ETSI TR 103 100 V2.1.1 (2019-03)

Operation of RFID in the UHF Band; Proposed improvements to be incorporated into future versions of ETSI EN 302 208

RTR/ERM-TG34-266

Figure 1: Measurement of tag emissions

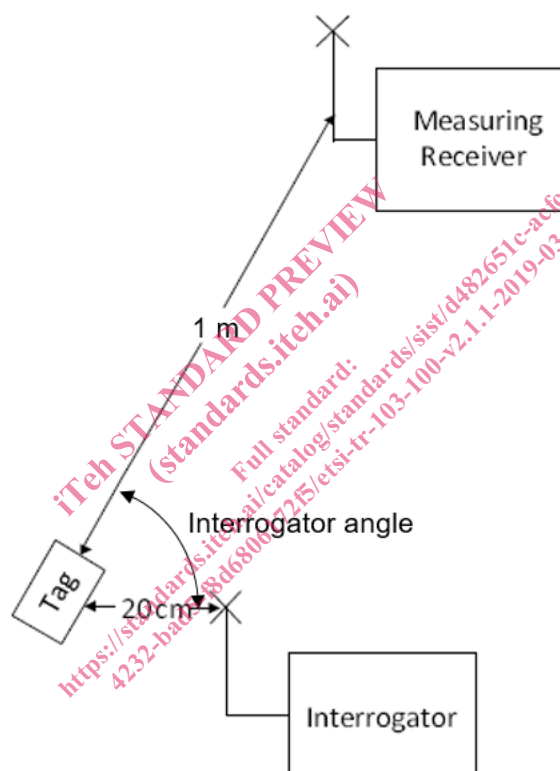
The method of test in ETSI EN 302 208 [i.1] should be amended to permit emissions from tags fitted with metal backplanes to be measured. The configuration should be changed from that shown in figure 16 in ETSI EN 302 208 [i.1] to that specified in the diagram in figure 1 with an interrogator angle of 0° to 60° between the tag-interrogator to tag-receiver line, whereas the receiver antenna should be placed in the direction of maximum gain of the tag.

Metal backplanes used for testing should be at least 40 cm in diameter, whereas any edge should be at least 20 cm away from the tag.

NOTE: 40 cm has been selected as it is greater than the longest wavelength of the frequencies from 865 MHz to 921 MHz.
